Florida Department of Transportation

SUBJECT: Temporary Design Bulletin C06-10
DCE Memorandum No. 28-06
Mandatory Utilization of Embedded Data Collectors (EDC) in Prestressed Concrete Test Piles

**EDC INSTRUMENTATION FOR
SQUARE PRESTRESSED CONCRETE PILES**

2006 Interim Design Standard
30" SQUARE PRESTRESSED CONCRETE PILE

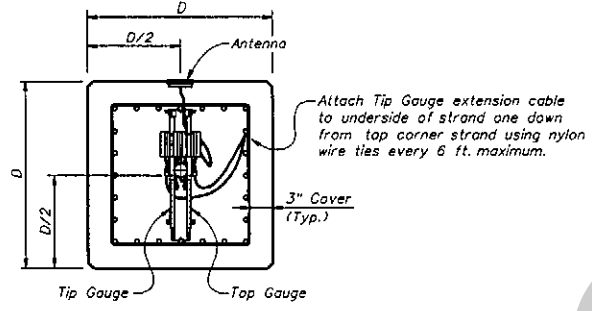
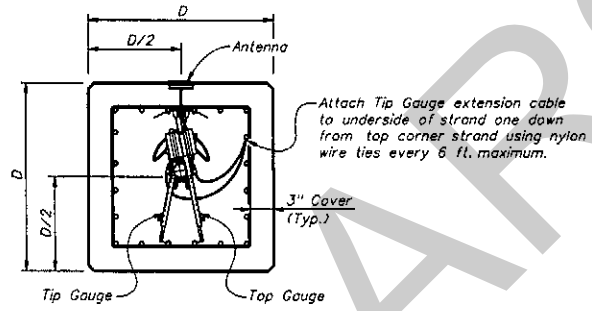
On all projects with bridges containing 18", 24" or 30" prestressed concrete test piles, modify the Summary of Pay Items to include Pay Item No. 455-146 (Embedded Data Collector – each). The Embedded Data Collector (EDC) quantity will be one per prestressed concrete test pile. Include Special Provision 455-5.12 in the Specifications Package for these projects. Review the plans to assure there are not any conflicts between plan notes and the new special provision.

In order to minimize the impact to each Districts' production schedule, a special provision has been drafted and forwarded to FHWA for review, and Interim Design Standards Index 20602 will provide EDC installation details. The special provision will need to be incorporated into the projects as a mandatory specifications change in the January 2007 Workbook.

Interim Design Standards Index 20602 will be posted on the Design Standards Website which will provide construction details for the EDC. The Design Standards Modifications (DSM) dated January 1, 2007 has been edited to include a reference to this Interim Index. Since no projects using this version of the DSM have been let as of this time, the date of the DSM remains unchanged. It therefore is not necessary to revise the DSM note on the Key Sheet.

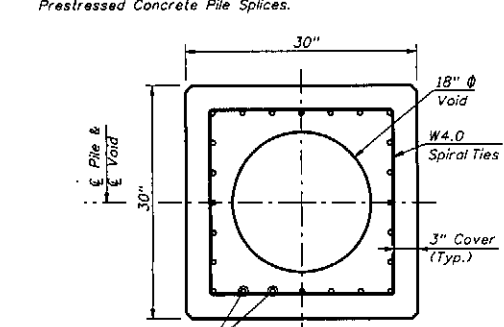
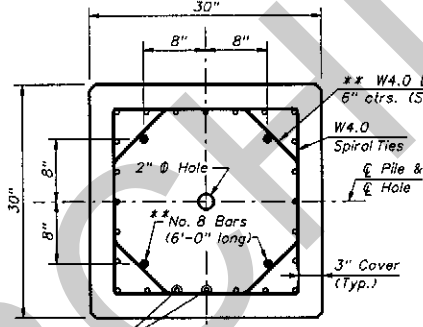
EDC can not be used with steel pipe piles or H-piles. In voided prestressed concrete piles, the length of the solid sections at the tip and toe of the piles shall be at least 4 pile diameters long. Design Standards Index 20630 for 30" Prestressed Concrete Piles has been revised to extend the solid section at the head and toe and will be released as an interim standard along with the interim standard for the EDC. The EDC will be cast into these solid sections, along the axis of the pile, ≥ 2 pile diameters from the end and ≥ 2 pile diameters from any cross-section change such as a pile void or vent.

DATE		BY		DESCRIPTION	
01/01/06	CEB			Added dimension "4'-0" Solid Section - Typical for Pile" & "11'-0" Solid Section - Typical for Splice Section" to ELEVATION.	
11/07/06	LEJ			Deleted 2" Ø hole in tip solid section. Deleted 3/4" Ø hole in opposite sides of pile. Changed 4'-0" Solid Section to 11'-0" Solid Section & changed Note 1. Added "Head & Tip" to "2" Ø Hole" in PILE SPLICE DETAILS.

1. Venting shall be provided by the use of a 1" Ø PVC conduit through a substructure cap or column. Voids between segments of spliced piles shall be connected by 2" Ø hole(s).
2. Any of the given Alternate Strand Patterns may be utilized. The strands shall be located as follows: Place one strand at each corner and place the remaining strands equally spaced between the corner strands. The total strand pattern shall be concentric with the nominal concrete section of the pile.
3. **CONTRACTOR OPTION:** The 30" pile may be cast SOLID by omitting the 18" Ø void, the 2" Ø holes and the 3/4" Ø vent holes. In this event, the Contractor shall submit calculations for approval and a proposed strand configuration that provide net prestressing after losses equal to 1000 psi.
